**PLANNED UNIT DEVELOPMENT &
SUBDIVISION STAFF REPORT**

Date: November 6, 2008

Sheffield Court Resubdivision, Resubdivision of Lot 9

SITE PLAN

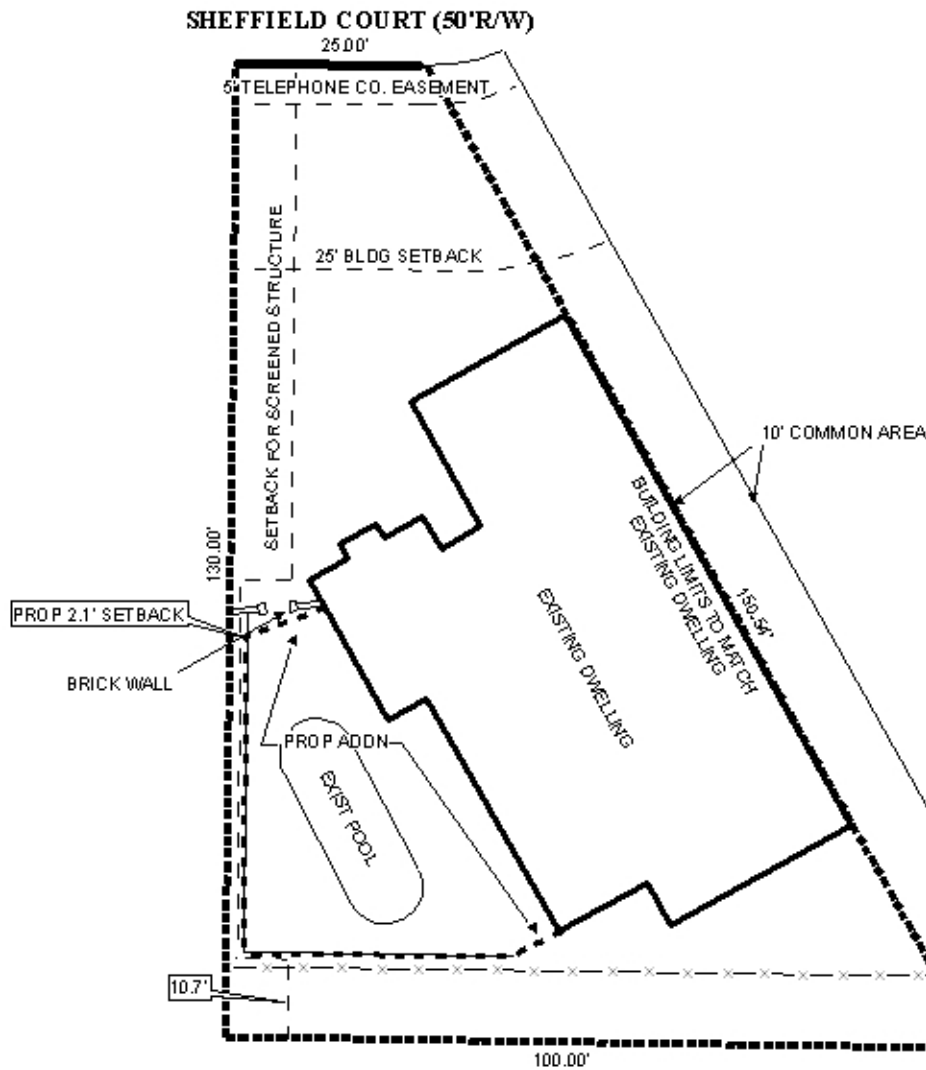
Though the site plan submitted shows the proposed setbacks for the new structure, it does not show the type of structure proposed nor does it show the exact location. According to #11 on the PUD application (and as required by Section 64.5.D.2.a.(6) of the Zoning Ordinance), *“the site plan, drawn to scale must illustrate the following information: dimensions of the site which will be affected; streets and easements bounding and intersecting the designated area; dimensions and locations of existing and proposed structures; yards/setbacks of existing and proposed structures; existing and proposed parking spaces, drive-ways and access points; buffer protections (such as fences or planting strip); and landscaping.”* Therefore, a holdover is recommended to allow the applicant to submit a revised site plan showing the footprint of the proposed structure along with all the exact dimensions and height. The applicant should also submit information regarding the proposed site coverage, if more than 35%.

- 1) Submittal of a revised plan showing the footprint of the proposed structure with labeling of all proposed setbacks, height information and site coverage; and
- 2) Revision of the plat labeling the size of the lot in square feet along with the size of all existing structures in square feet.

According to the applicant, the addition will be a 1276 ± square foot screened pool enclosure, 14 feet in height with a screened roof. The proposed screen structure will be 2 feet 1 inch from the West property line, which is abutted by a zero-lot line single-family residence with corresponding overhang. The proximity of the adjacent residence and the

decrease in accessibility is a concern. It should also be pointed out that approval of this structure will set a precedent for reduced setbacks for other lots within the development.

The existing residence has a footprint of 2965 square feet, and with the proposed 1276 square foot screen enclosure, 52% of the site will be covered in structure.

- 1) Construction of the screen structure, as proposed, will adversely effect the adjacent property by reducing access for emergency personnel, thus creating a safety hazard;*
- 2) Approval of the proposed reduced setbacks will set a precedent for other properties within the development; and*
- 3) Approval of the proposed reduced setbacks may result in the violation of Building Code requirements.*

- 1) Placement of a note on the site plan and final plat stating that the screened enclosure is limited to 14' in height, 1275.9 square feet in size, and may only have a screened roof and sides;*
- 2) Placement of a note on the site plan and final plat stating that the screened structure will meet all building code requirements regardless of the location on the lot; and*
- 3) Submittal of a revised PUD prior to signing of the final plat.*

- 1) Placement of a note on the site plan and final plat stating that the screened enclosure is limited to 14' in height, 1275.9 square feet in size, and may only have a screened roof and sides;*

- 2) Placement of a note on the site plan and final plat stating that the screened structure will meet all building code requirements regardless of the location on the lot;*
